MEETING MINUTES

Crane Lake
Voyageur's National Park Visitors Center and Campground
December 16, 2021 at 2:00 PM
SEH No. CRALT 163725

Schematic Site Layout
VNP VISITOR'S CENTER
CRANE LAKE TOWNSHIP, MN

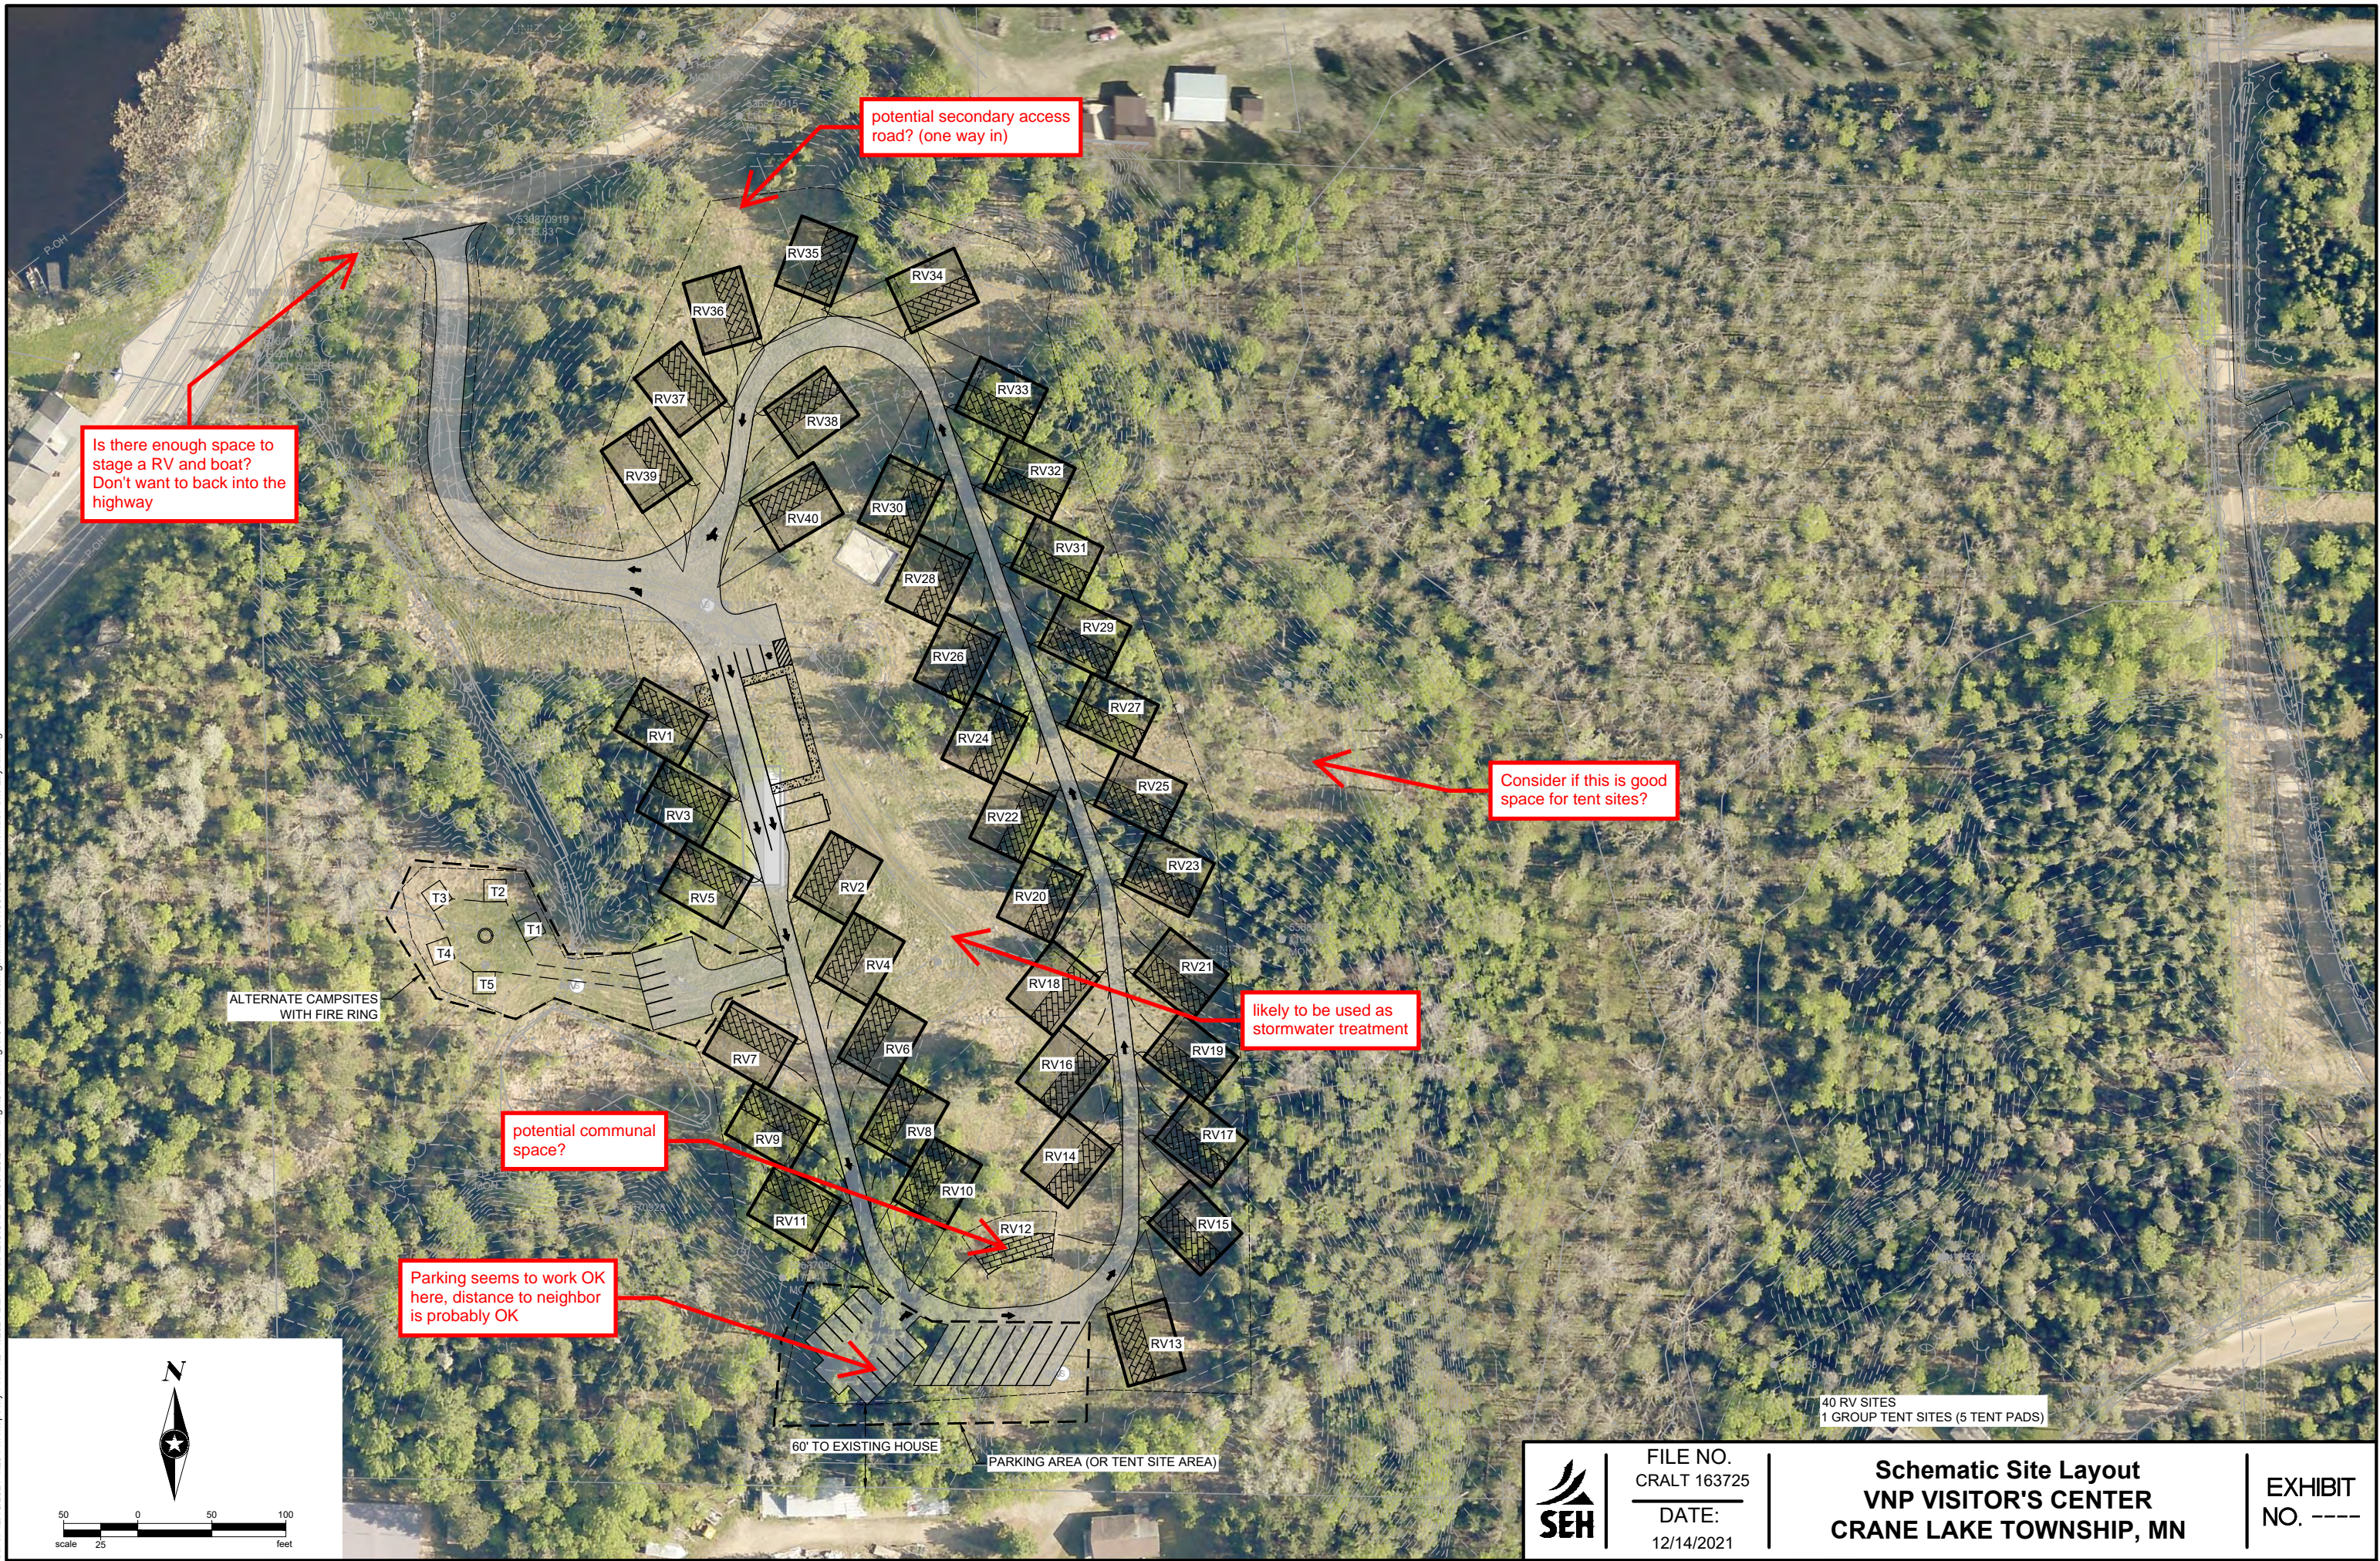
- D. Bayside Drive ownership
 - 1. SEH still working on identifying easements, etc.
- E. Other
 - 1. Campground layout review
 - a. Discussion on additional access road, what happens if you miss your turn?

- b. Plan to include a fire ring at each site, but this isn't set in stone.
 - c. Might not be able to actually fit all 40 sites shown, but this is a goal. 35+ is desirable.

potential secondary access road? (one way in)

Is there enough space to stage a RV and boat? Don't want to back into the highway

Consider if this is good space for tent sites?

likely to be used as stormwater treatment

potential communal space?

Parking seems to work OK here, distance to neighbor is probably OK
